City of Pawtucket, RI

***** Addendum #1 *****

RFP # 14-057D
Synthetic Turf Field Design

November 9, 2015

EXISTING CONDITIONS PLAN

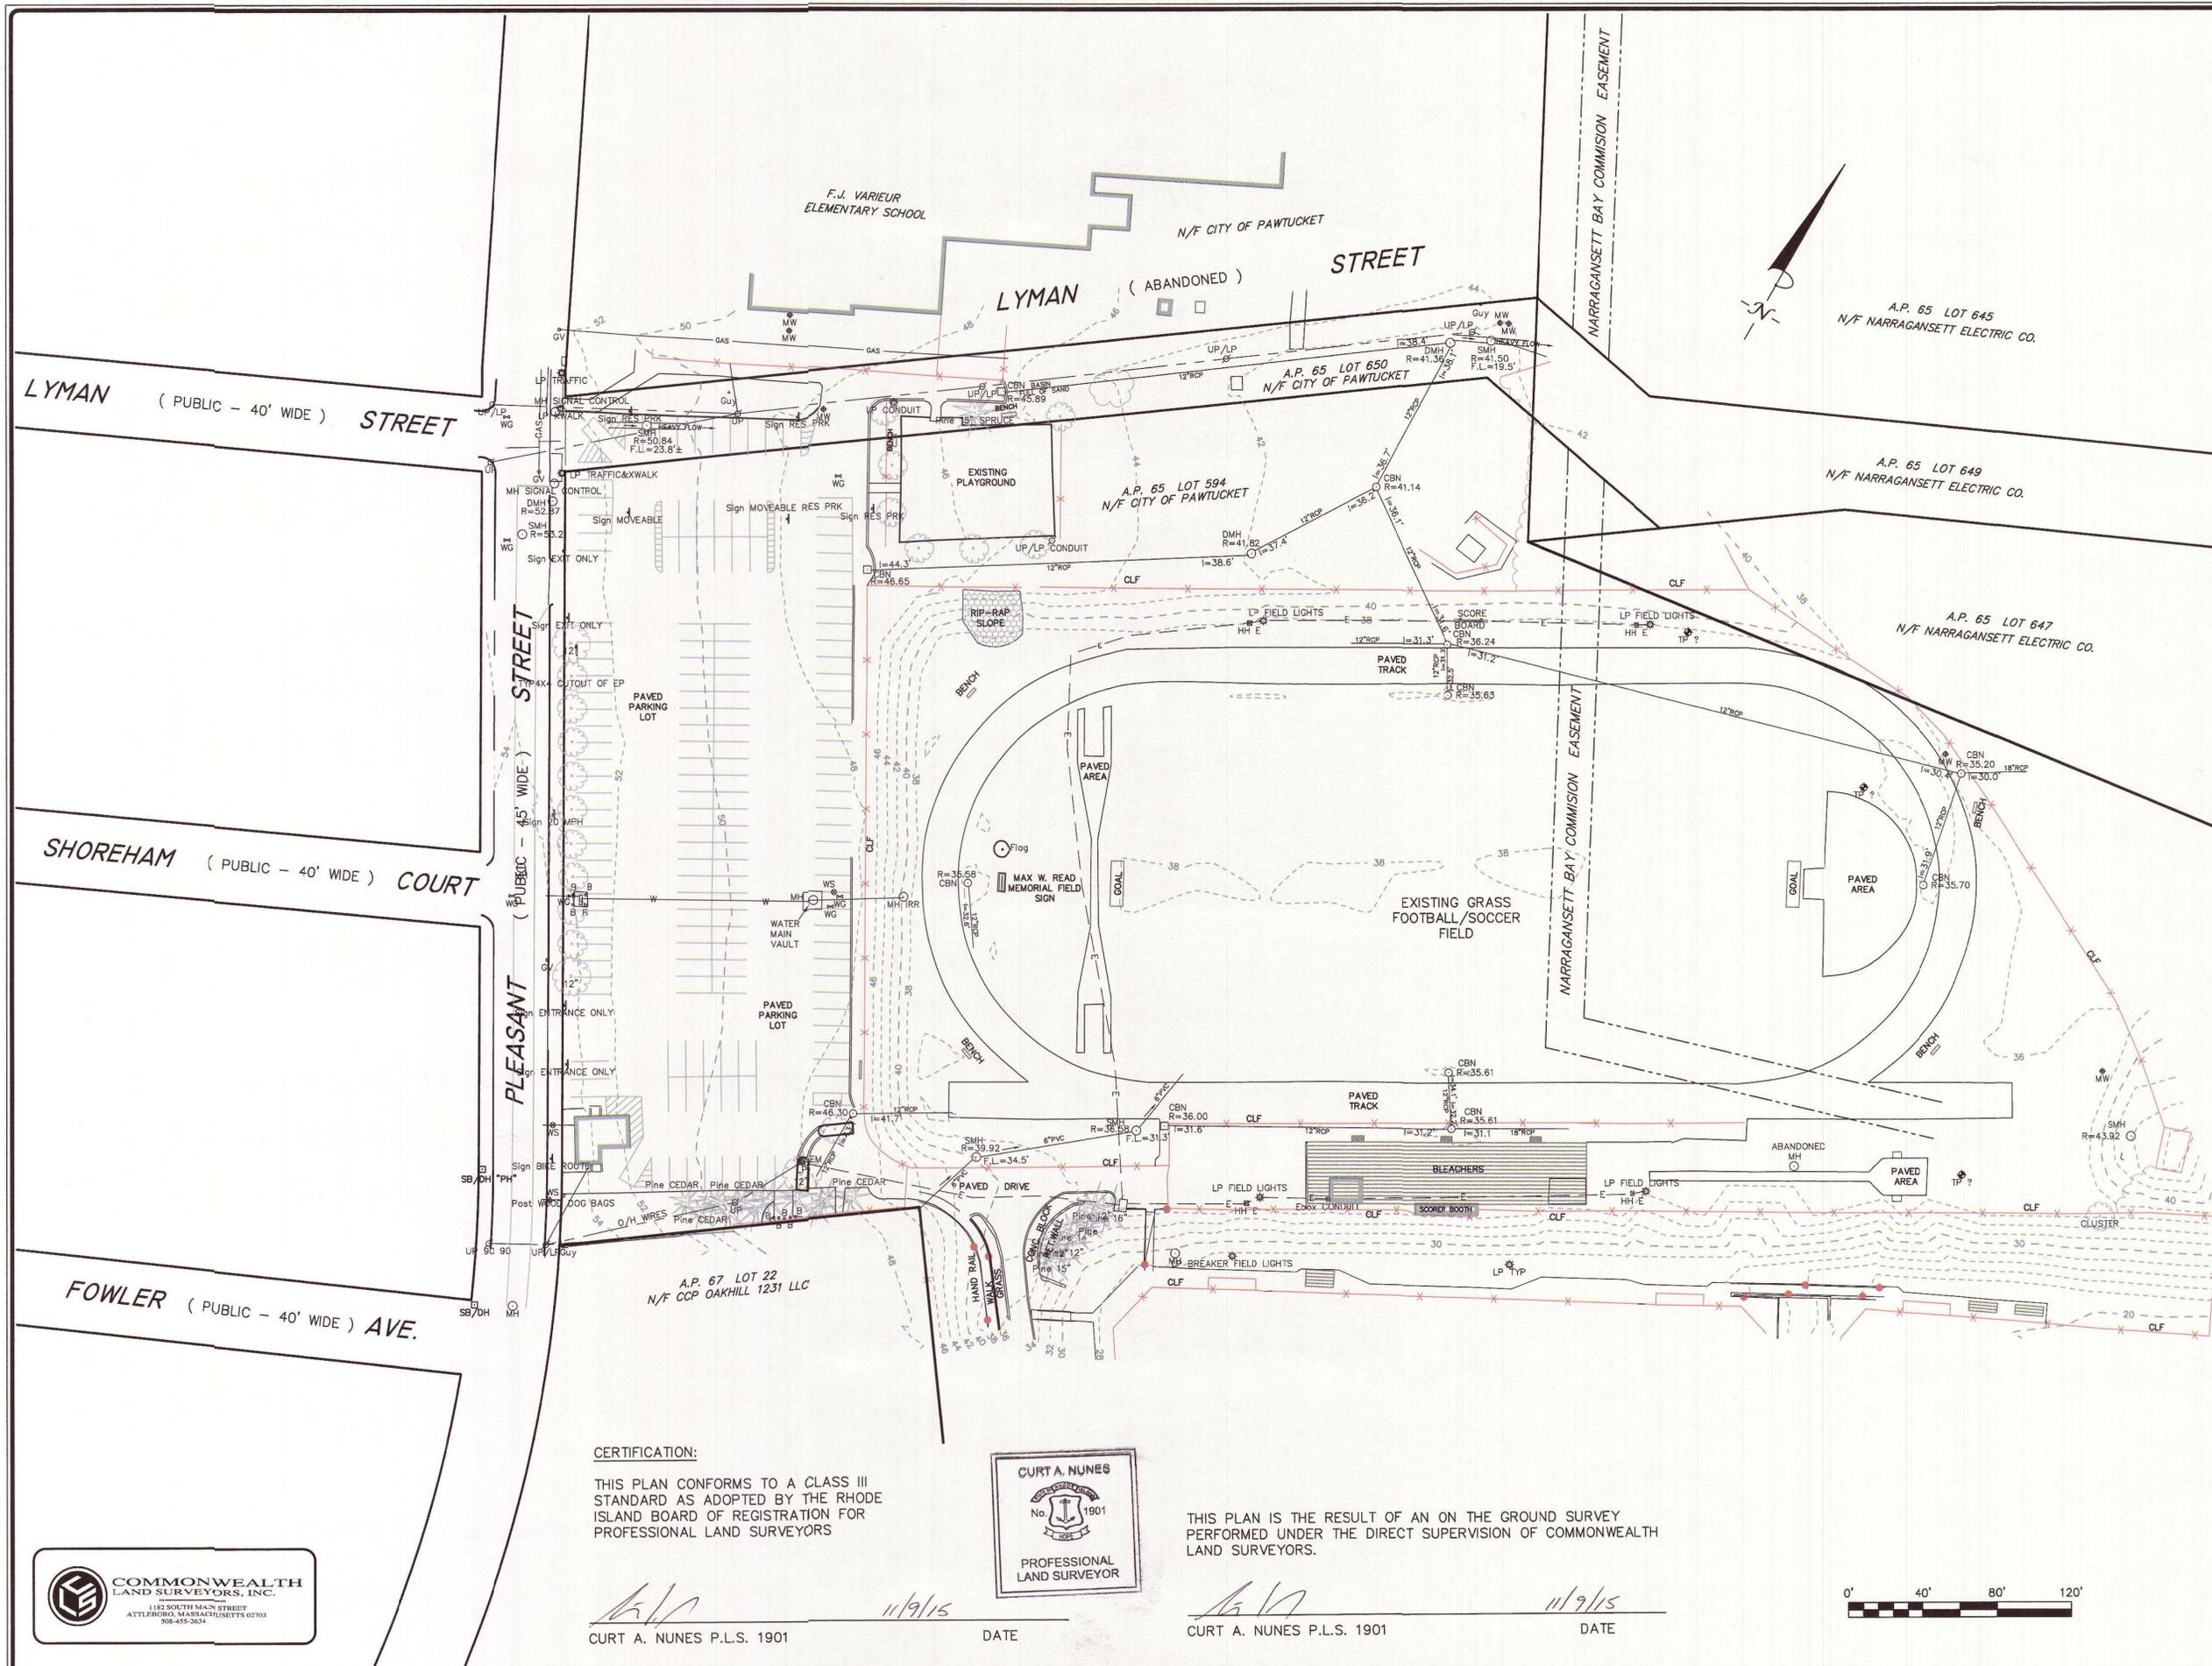
Q1: Please provide a copy of the Class I boundary and topographic survey

A1: *A draft survey plan showing existing conditions is included herein as Attachment 1. The final plan will be available as of the award of this contract.*
